M1070P1 HET Tractor...

WAIT! WE'VE GOTTA
MODIFY THE ESCAPE
HATCH FIRST!

Escape hatch jams against exhaust shield support bracket

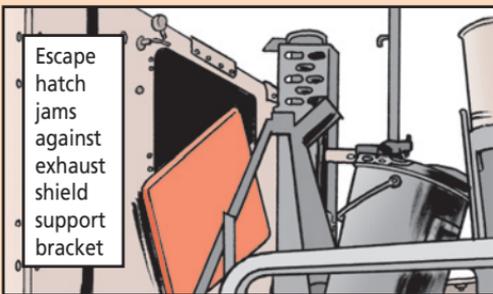
The rear escape hatch can wedge against the exhaust shield support bracket when you try to open the hatch. That leaves only a partial opening that's not large enough for you to escape through. That means if you're involved in an accident or incident and the escape hatch is the only way out, you could be trapped.

To eliminate the interference with the escape hatch, remove the exhaust shield support and antenna, modify the support and reinstall it to the top of the storage box. Modification requires cutting the existing support, welding a new mounting plate to the cut end and then spot painting the plate.
